Release Notification and Corrective Action

Name of Company Hilcorp Energy Company	Contact Lindsay Dumas
Address 1111 Travis St. Houston, TX 77002	Telephone No. (281)794-9159
Facility Name: SJ 27-5 110N	Facility Type: Gas
Surface Owner State	Mineral Owner State
API No. 3003927767

SOIL SAMPLING LOCATIONS, FIELD PID-OVM READINGS, LABORATORY ANALYTICAL RESULTS, AND EXCAVATION RECOMMENDATIONS
 DECEMBER 2017 AND JANUARY 2018
 HILCORP ENERGY
 SAN JUAN 27-5 UNIT 110N
 NE¼, NE¼, SECTION 2, T27N, R5W
 RIO ARriba COUNTY, NEW MEXICO
 N36.60656, W107.32165

FIGURE 3

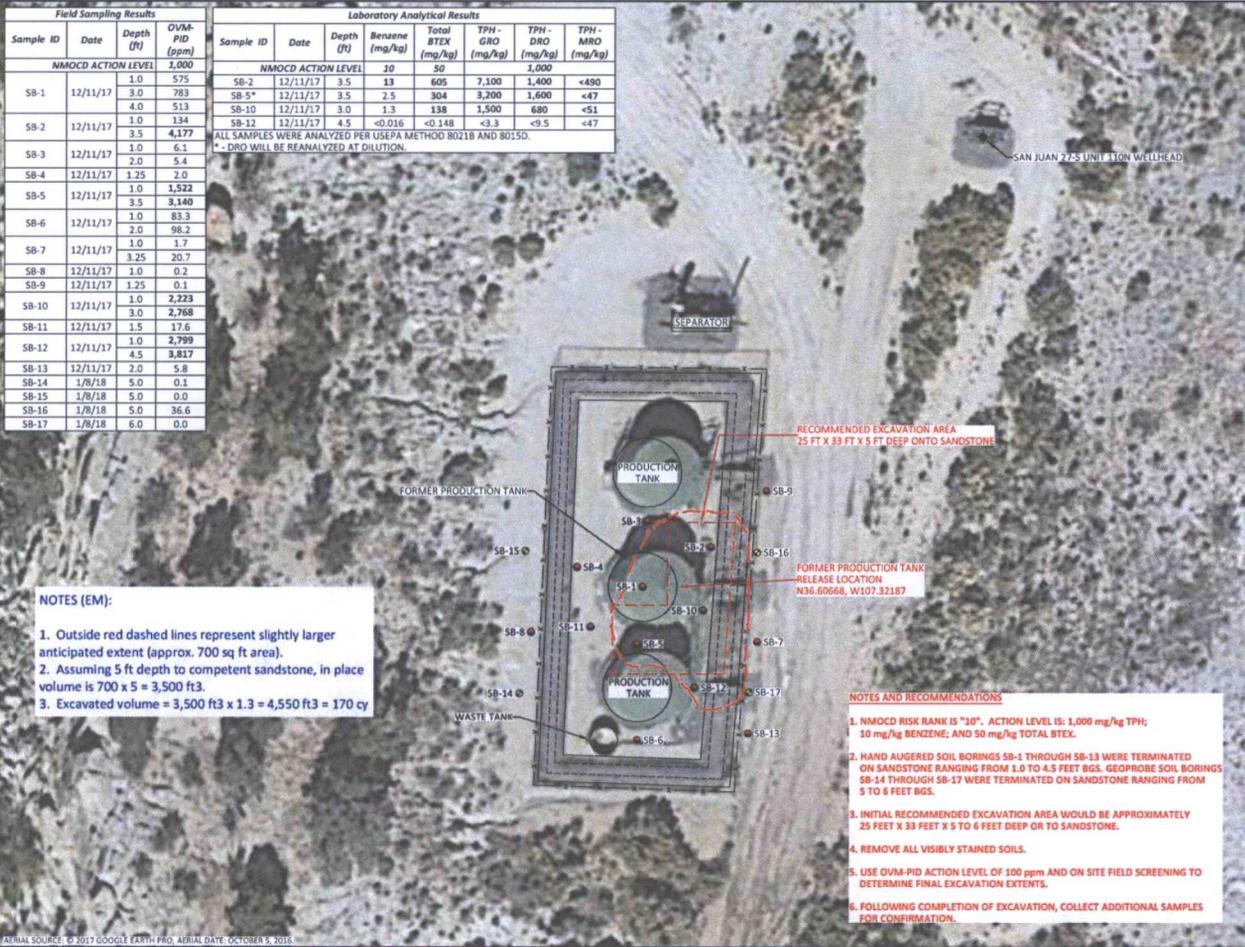
Signature: 	OIL CONSERVATION DIVISION	
Printed Name: Lindsay Dumas	Approved by Environmental Specialist: 	
Title: Environmental Specialist	Approval Date: 4/10/18	Expiration Date:
E-mail Address: Ldumas@hilcorp.com	Conditions of Approval: SAMPLE FOR TPH, BTEX, BENEENE	Attached <input type="checkbox"/>
Date: 2/8/2018 Phone: (281)794-9159	Each 100' stock pile must be sampled

With 6 weeks of Excavation piles that fail must be removed Any Amendments must Be Approved by ocd prior to use. Sample vadose zone after Remediation is complete.

Based on the attached final delineation report, Hilcorp plans to excavate approximately 170 cy of soil, confirmation sampling of excavation walls will occur and NMOCD & SLO will receive 48 hour notification to witness.
